Date December 13, 2022
To Town of Cumberland Planning Board
From Carla Nixon, Town Planner
Subject **Final Major Subdivision Plan Review: White Rock Terrace Apartments**

Travis Letellier, P.E. of Acorn Engineering, Inc., is the Applicant's representative. Dan Diffin, P.E., of SYTDesign Engineers reviewed the plans for the Town of Cumberland.

PAK
WGS

C-10

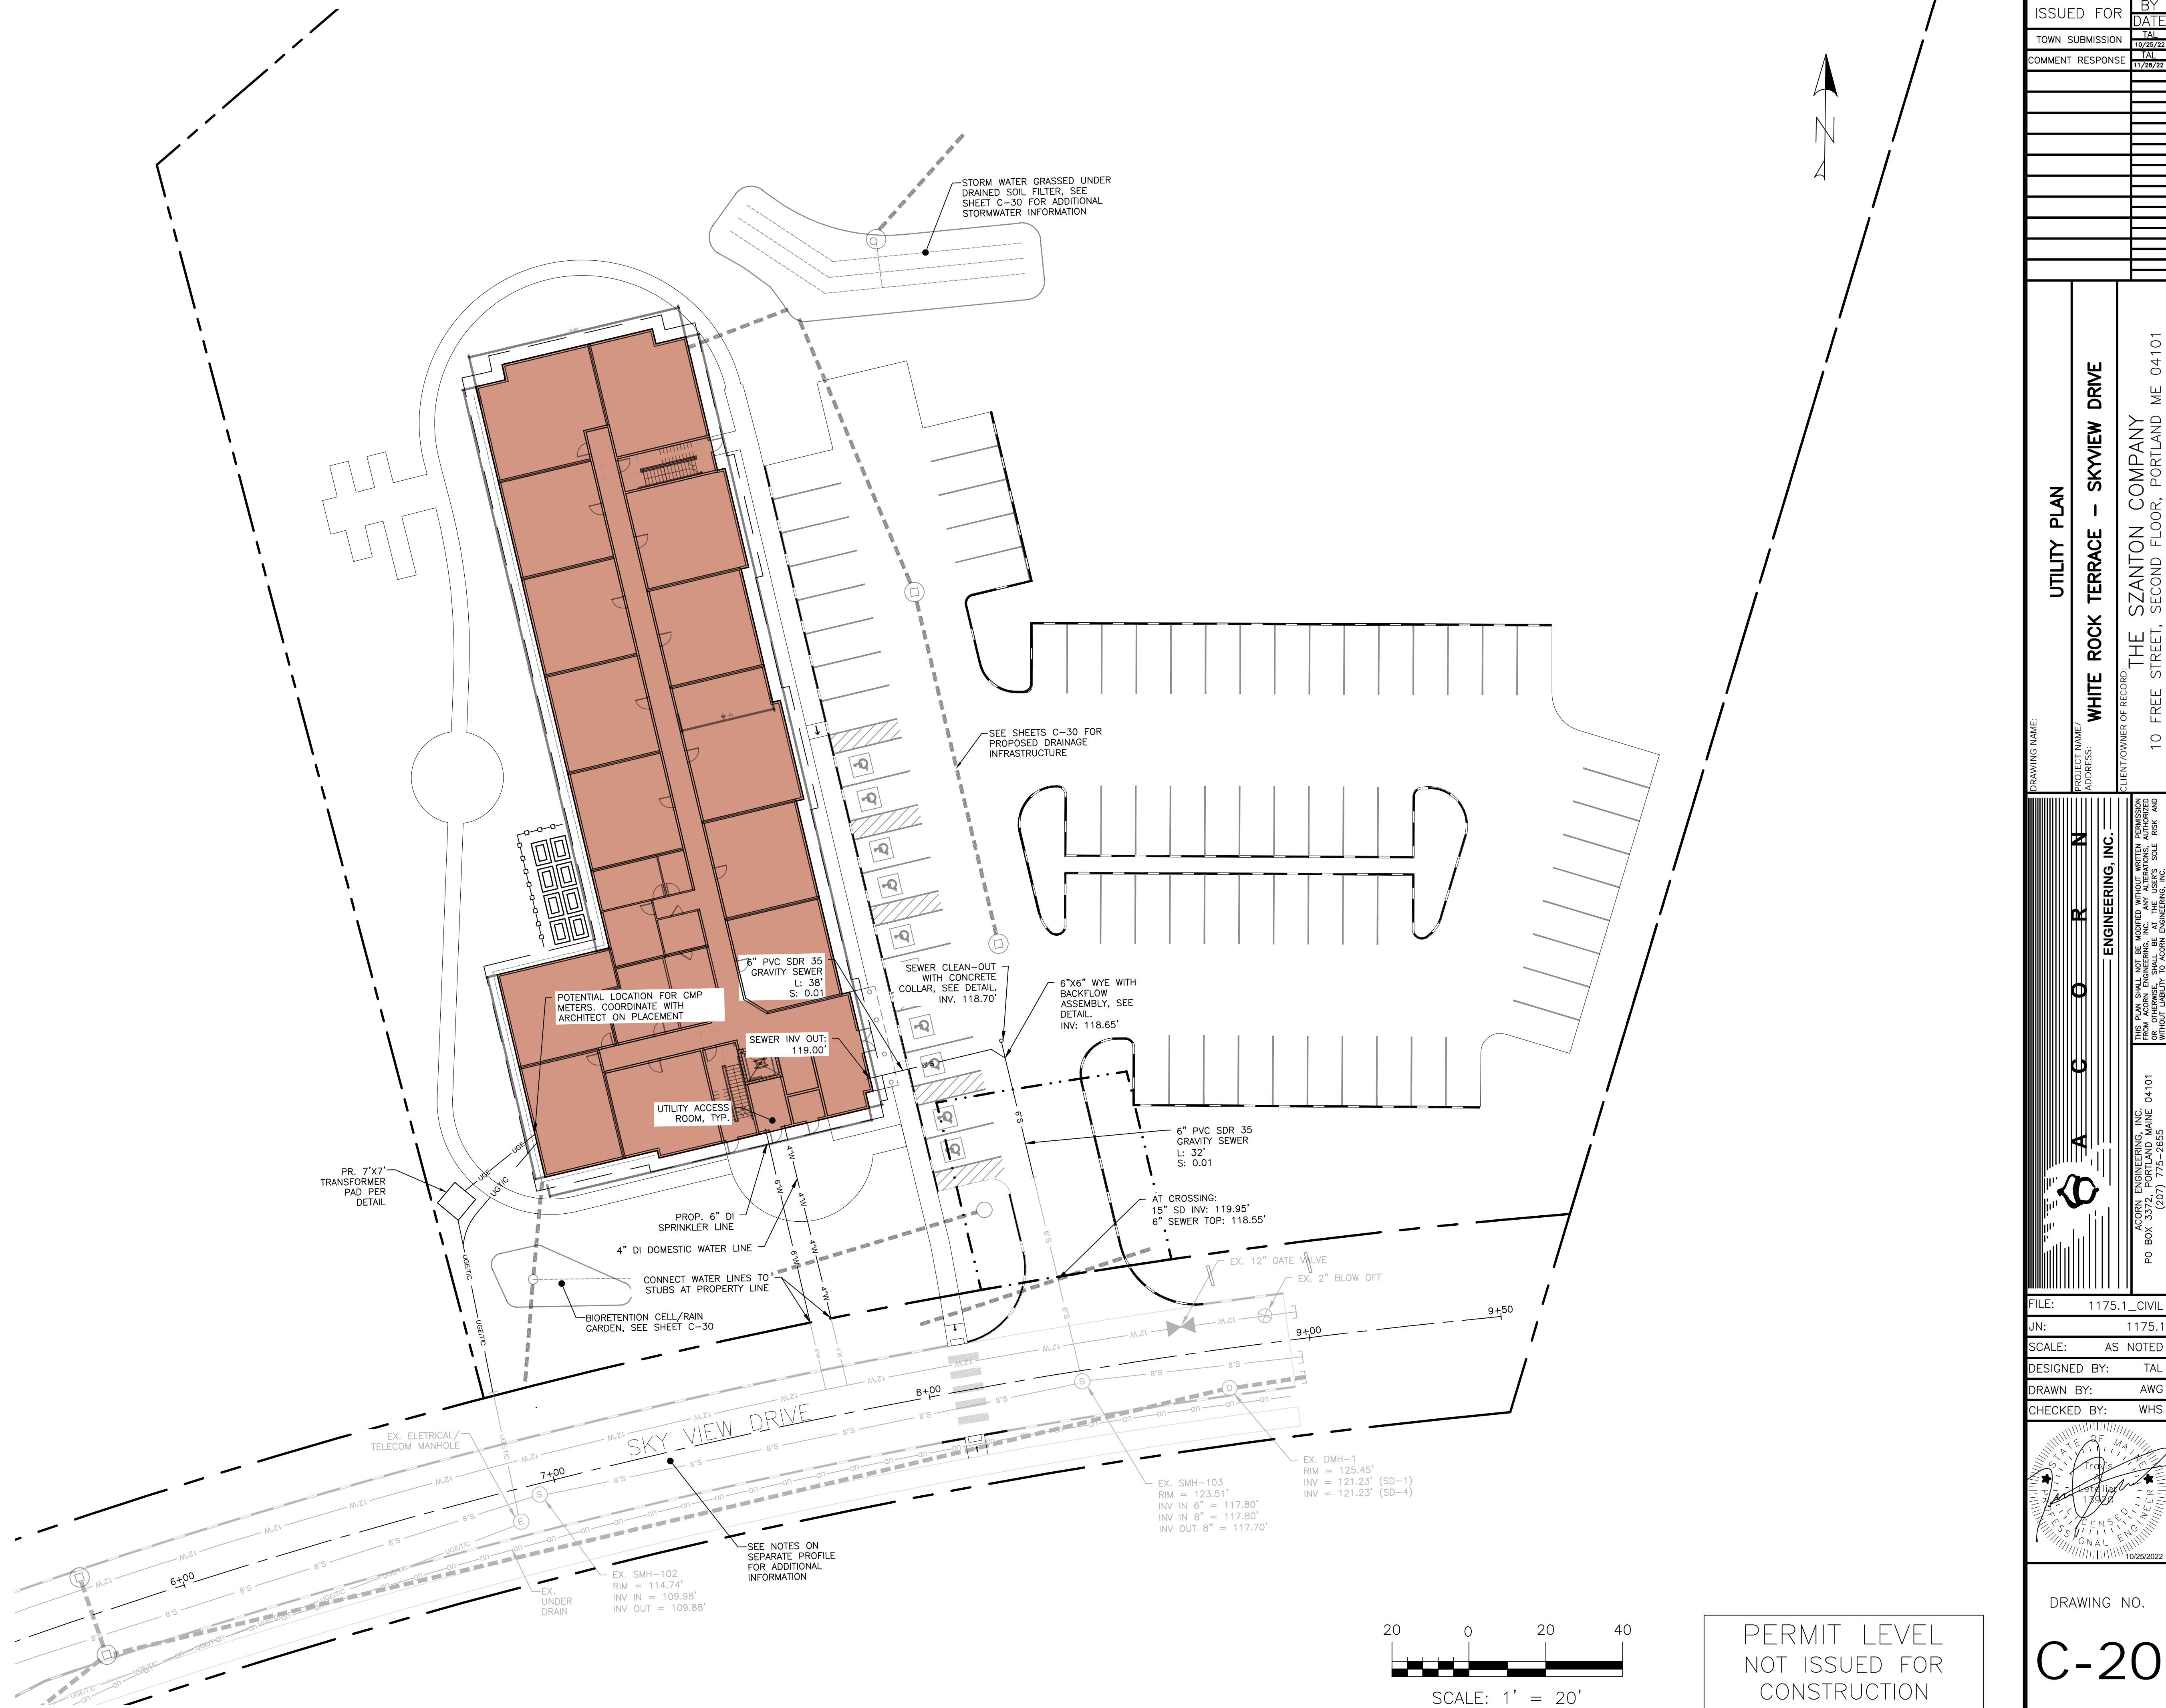
Comment – *Plan Sheet C-10- Overall Site Plan - There was no ADA Van Accessible spot proposed. SME recommends the applicant adjust the parking layout to allow one ADA compliant Van Accessible Parking space per ADA requirements.*

Response – There will likely be eight heat pump condenser units for the property, each located on a 4'x6' concrete pad, located on the updated plans. Noise will be buffered by the building and by a fence surrounding the units. See Sheet C-10 for location of the concrete pads.

PAD MOUNTED TRANSFORMER
NOT TO SCALE

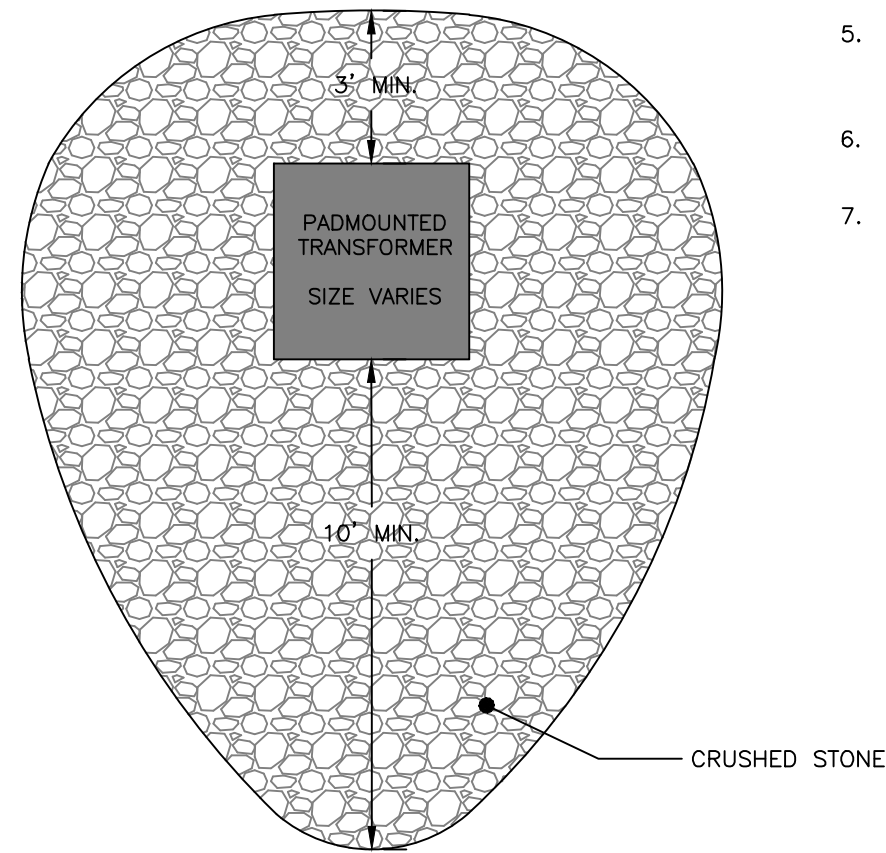
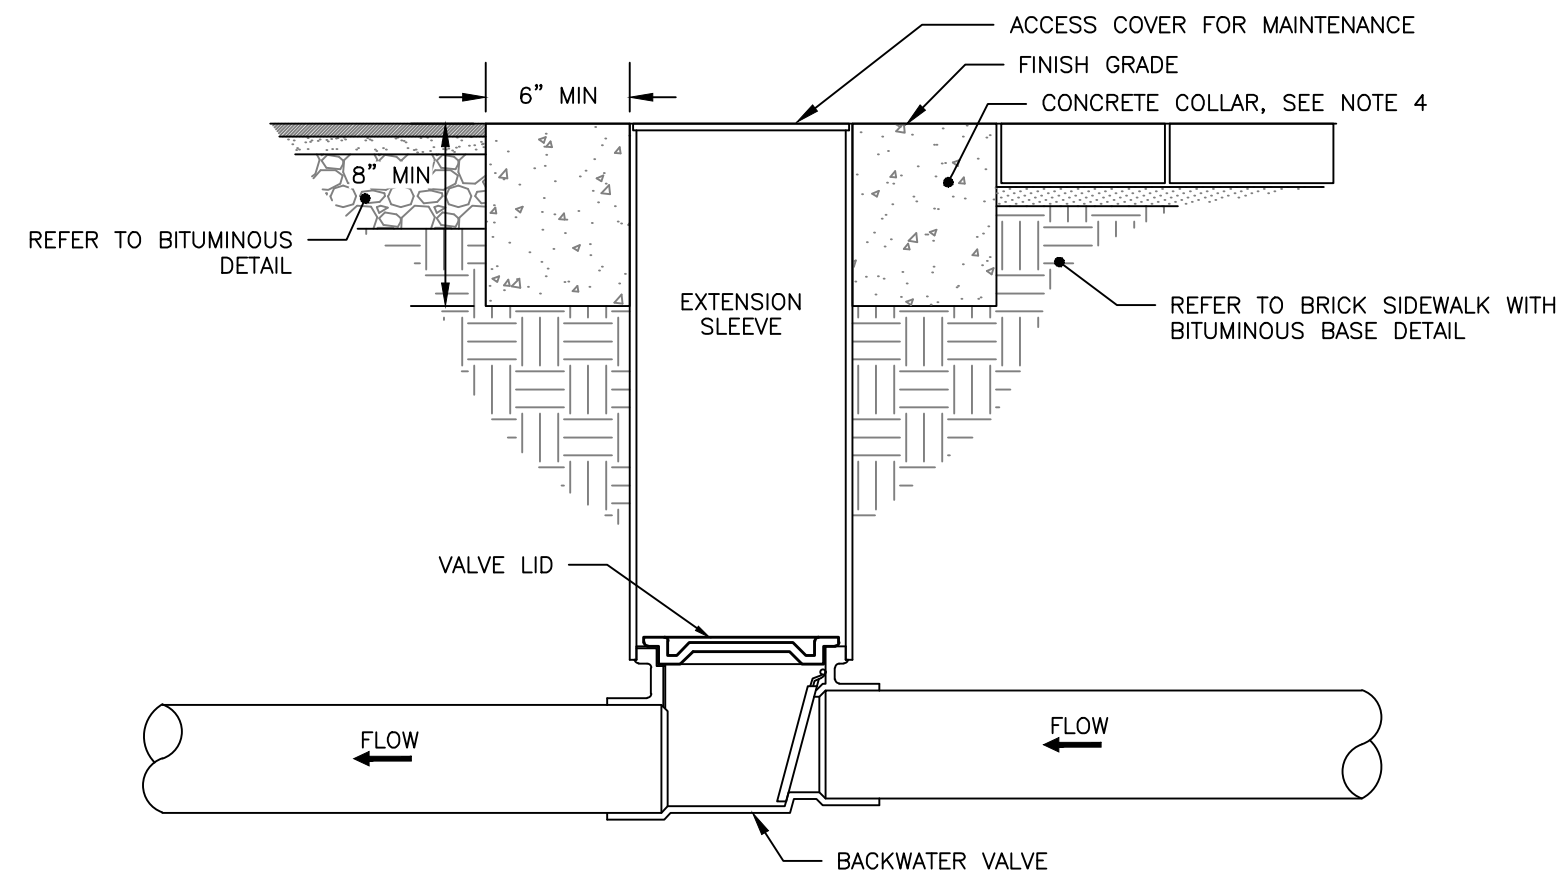
Comment – *Plan Sheet C-20 – Please confirm that a 4-foot by 4-foot transformer pad is large enough for this level of development. More typical sizes are 7-foot by 7-foot or 9-foot by 9-foot.*

Response – MEP guidance is forthcoming, but likely a 7x7 transformer pad will be required. This is updated on Sheet C-20.

OVERFLOW SPILLWAY DETAIL
NOT TO SCALE

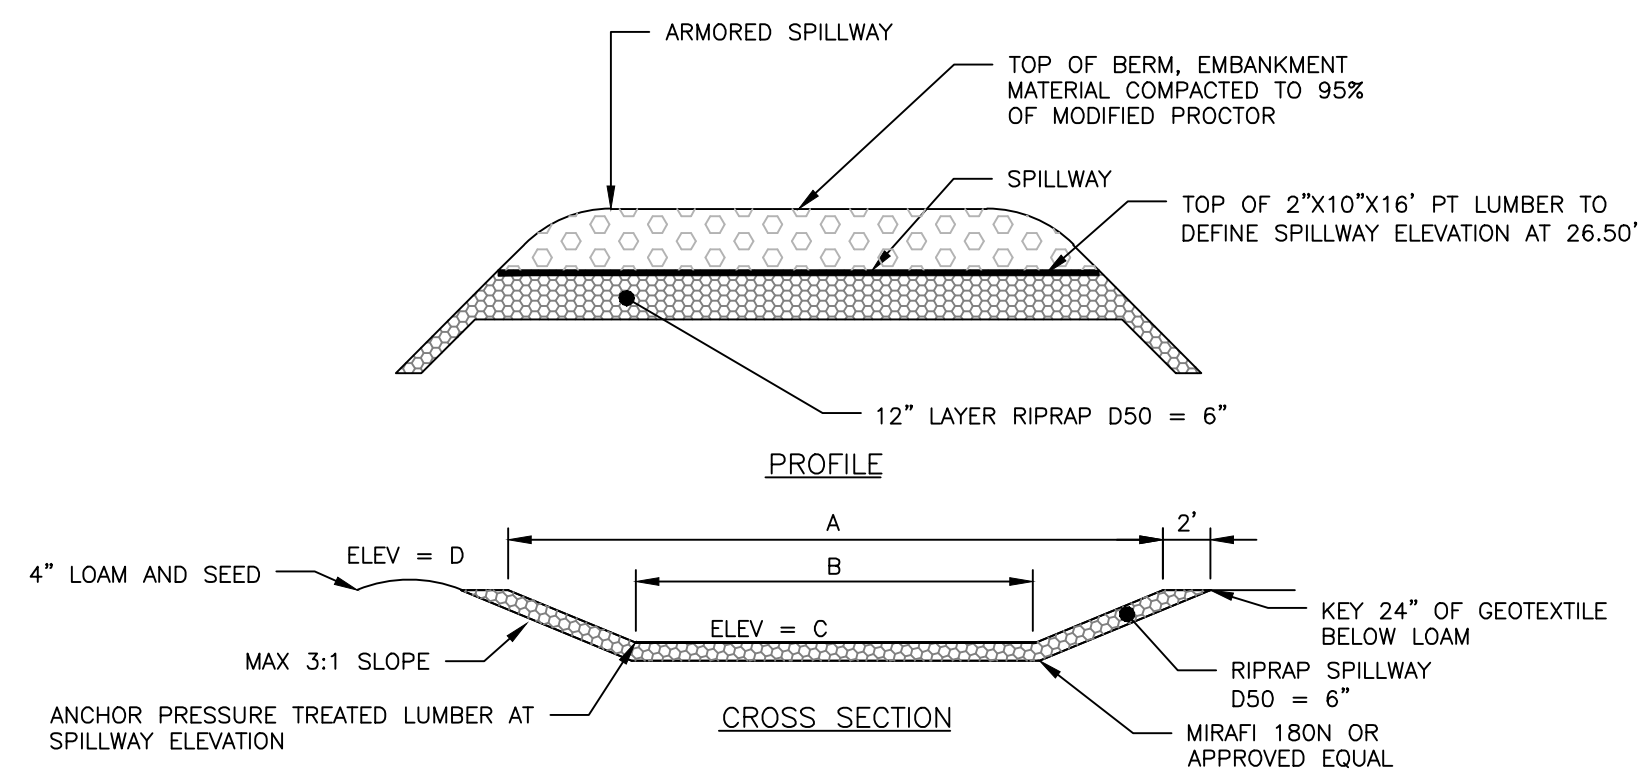
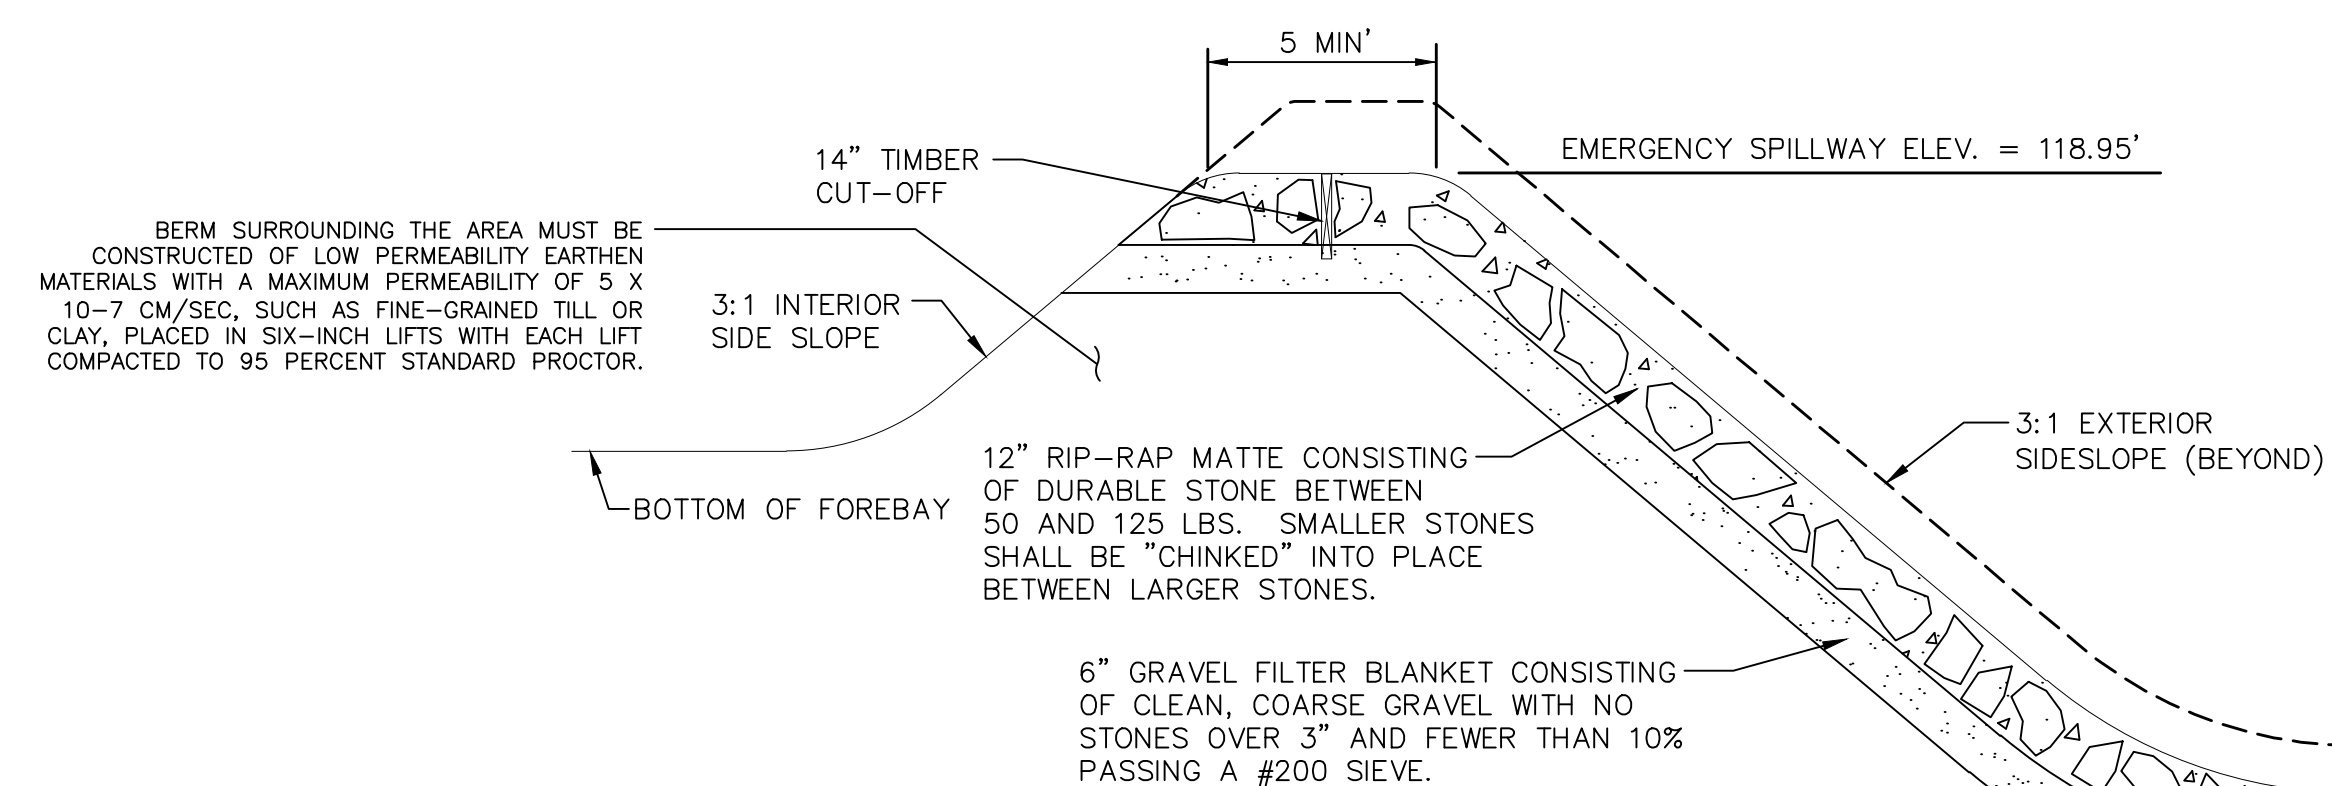
Comment – *Plan Sheet C-30 – Grading and Drainage Plan – please provide dimensions for the rip rap emergency overflow on the GUSF.*

Response – Dimensions for the rip rap emergency overflow on the GUSF have been provided on Sheet C-30. Details for the spillway have been added to Sheet C-44.
